2.0 PROXIMITY AND NOISE

**Glen Dhu Power-Wind Project
Registration Document
Addendum**

Figure 2.1
Revised Wind Turbine Location
Map

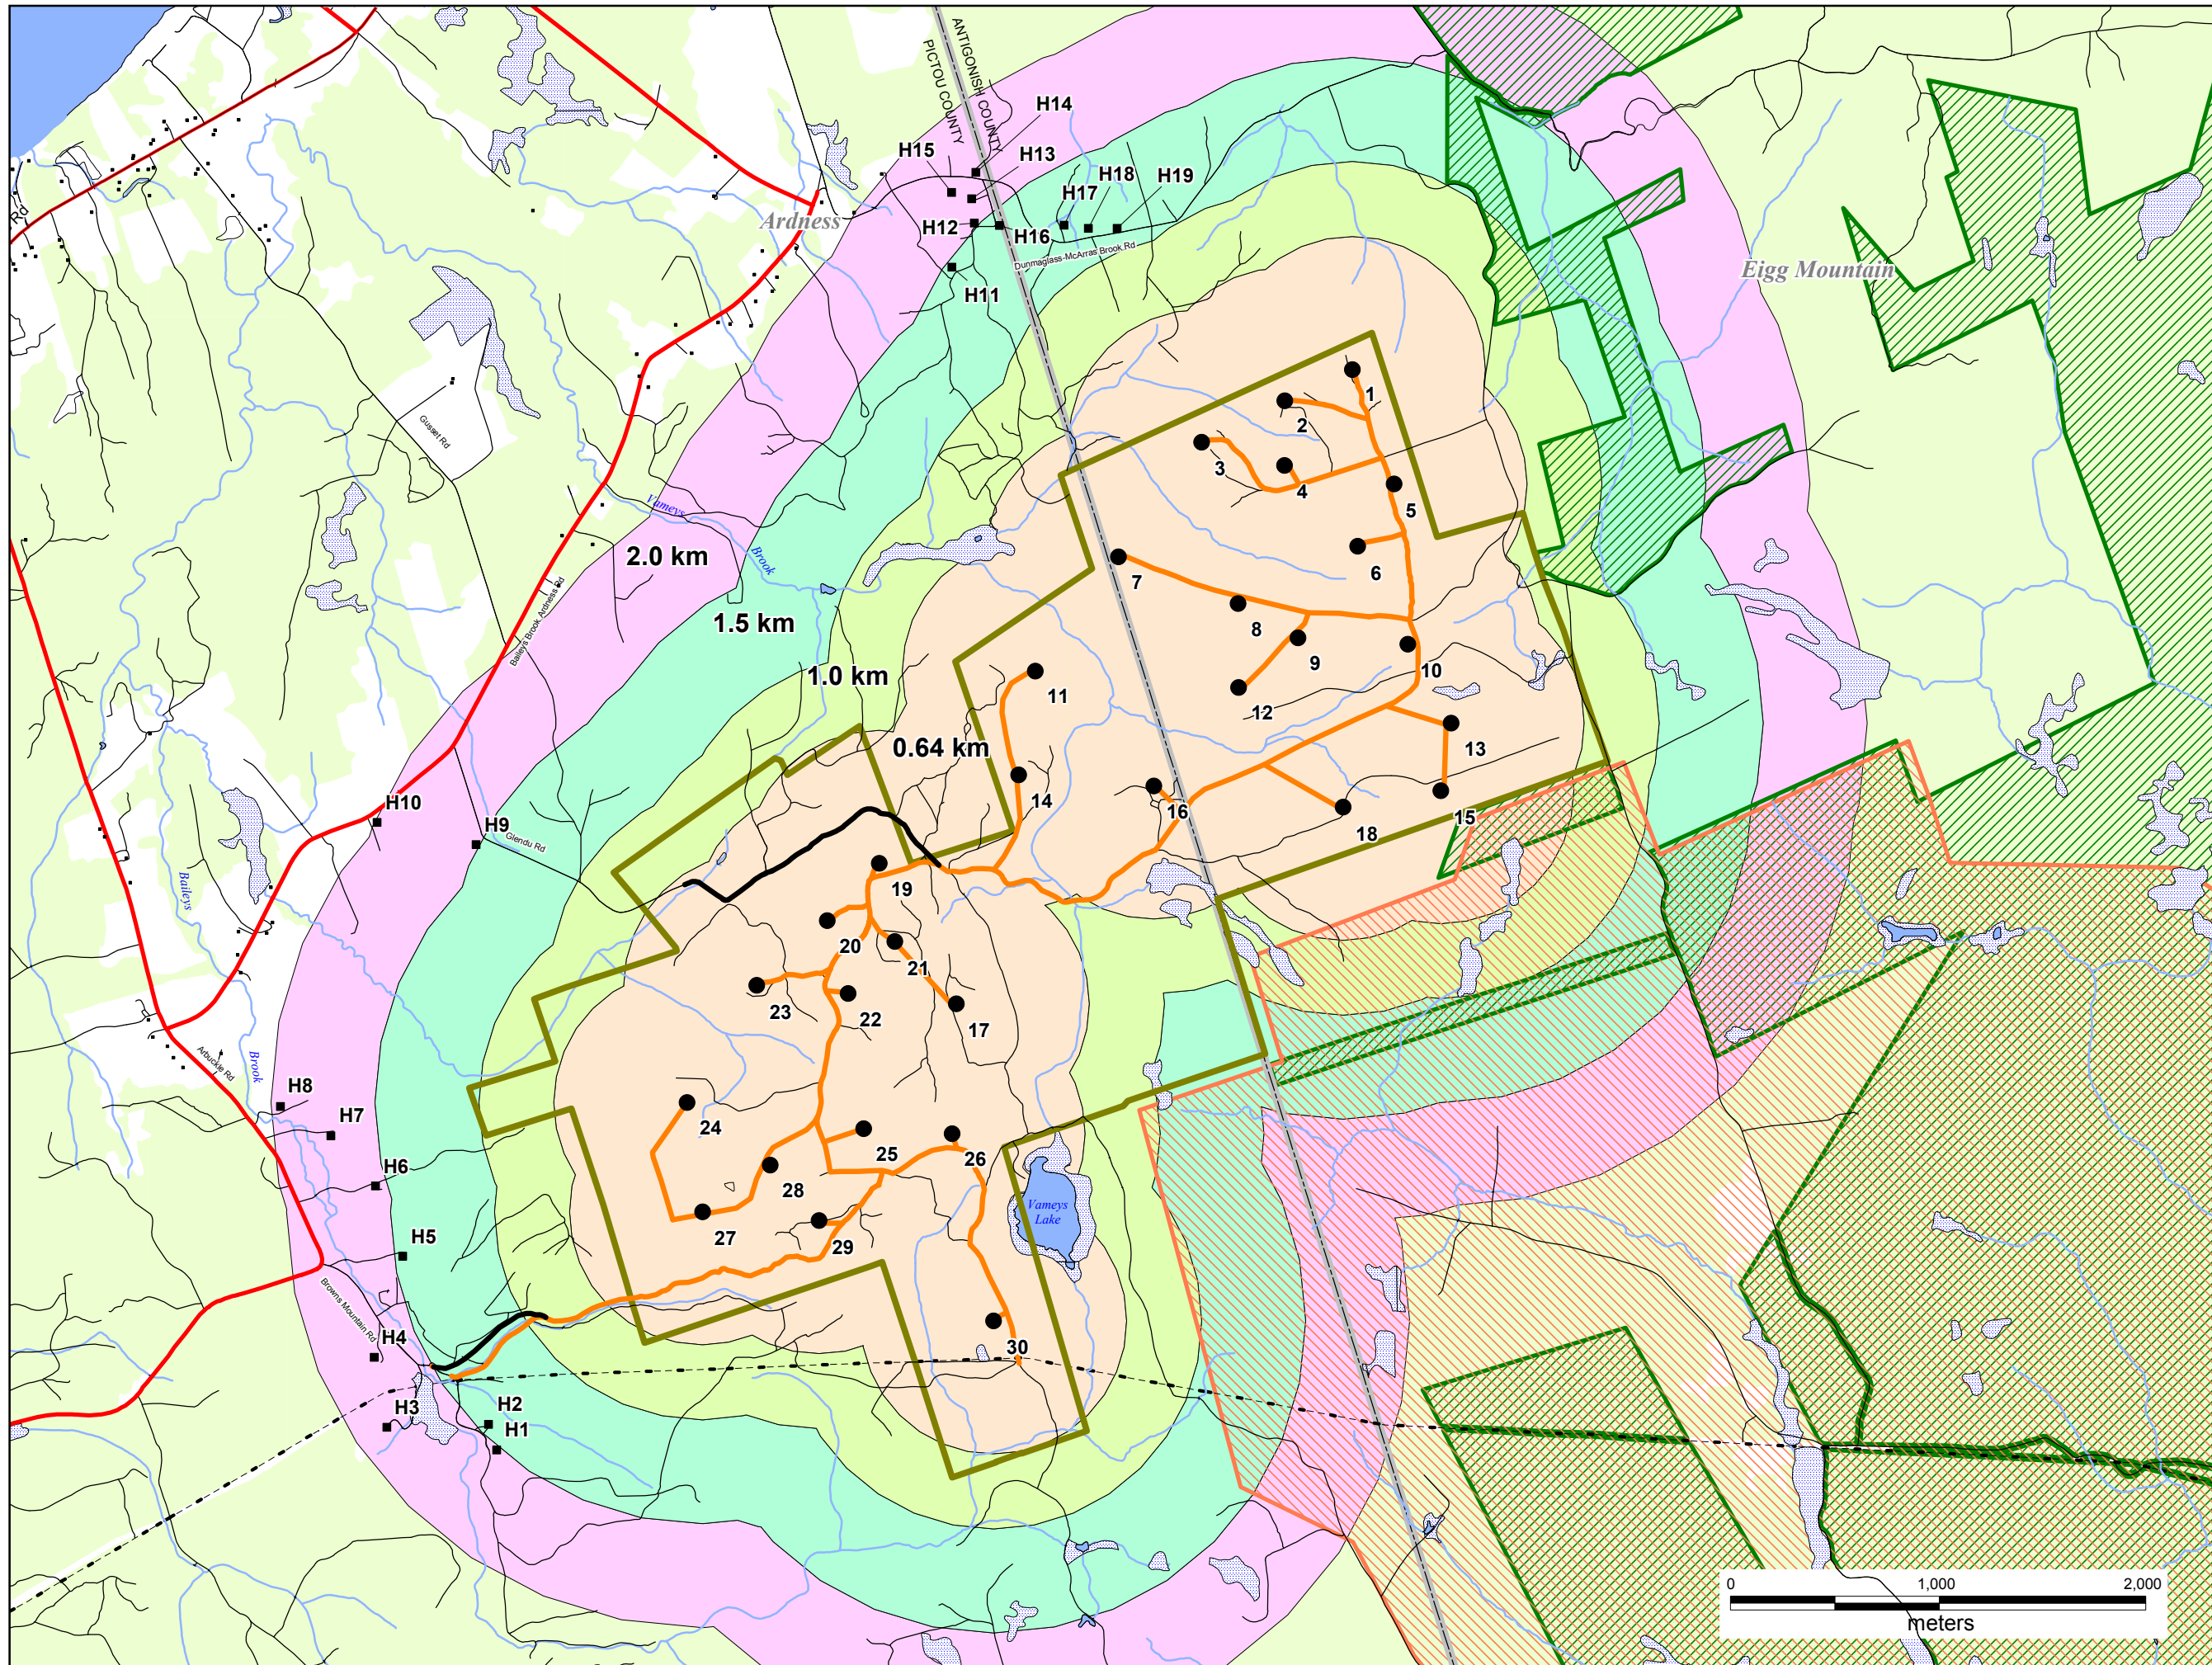
Figure 2.1 shows the revised turbine layout and physiographic features of the Project area. The site plan indicates that proximity of turbines to residences has increased to a minimum of 1.44 km. Figure 2.2 shows the project area with distances to nearest residences of 640 m (original minimum distance), 1000 m, 1500 m, and 2,000 m. There are no day cares, hospitals, or residences for senior citizens within this 2,000m zone. Table 2.1 shows the number of residences within each of the above distance intervals. The minimum setback of wind turbines from dwellings required for Pictou County is 600m and the minimum setback for Antigonish County is proposed to be 1000m.

As shown in Figure 2.1 and noted in Tables 2.1 and 2.2, the updated layout as been adopted to mitigate concerns about noise and proximity. The updates to the original layout include:

- Deletion of four sites (as the original study had four extra sites to allow some design flexibility);
- Adjustment of the remaining closest turbines along the western edge of Project area;
- Adjusting the turbine locations along the entire northern section of the Project area.

The letters sent in regarding the issue of proximity to residences was concentrated on the western boundary of the Project. These three houses, of which the nearest was roughly 640m, on the original layout for the EA submission, now lie no closer than 1.44 km from the nearest turbine. The revised layout means that no turbines are located within a 1.44 km distance of any non-participant residences. The noise model indicates that sound levels at these distances are at typical background levels for rural locations.

**Figure 2.2
Wind Turbine Proximity
to Residences Map**

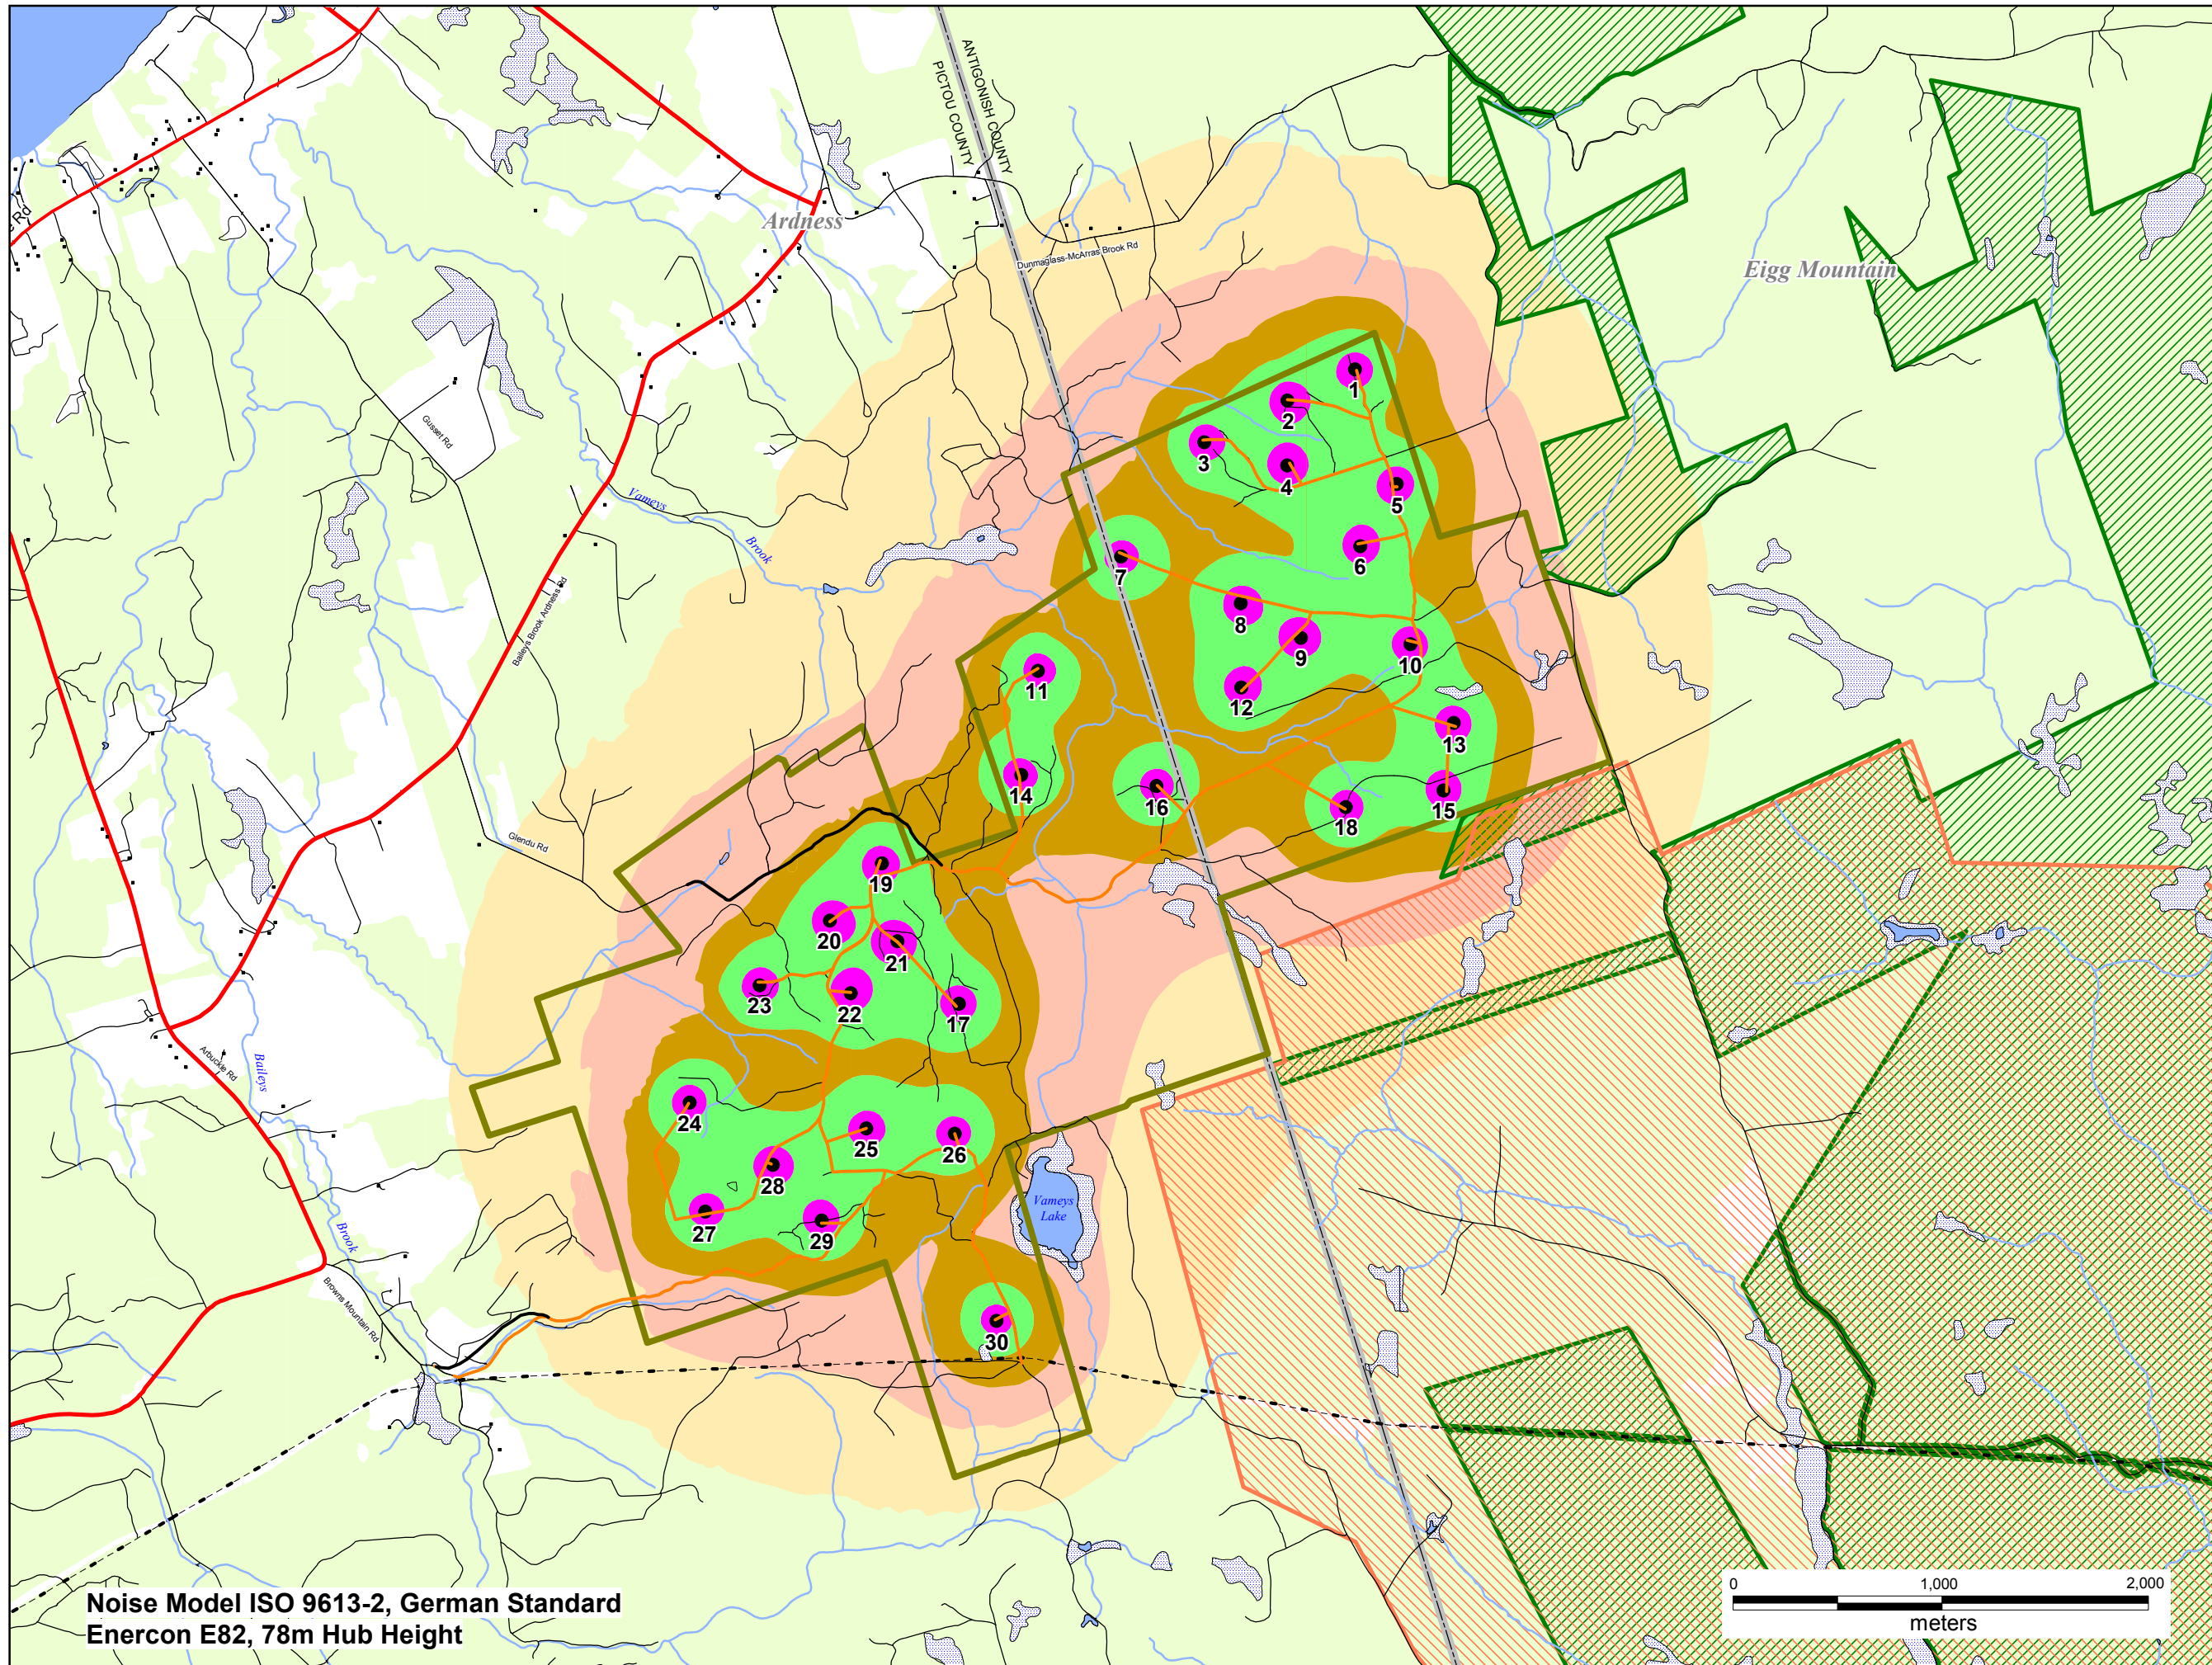
Table 2.2 shows the numbers of turbines visible from homes in the 1000-1500 m range and the 1500 - 2000m range. The house numbers are identified on Figure 2.2. The homes of Project participants are also identified.
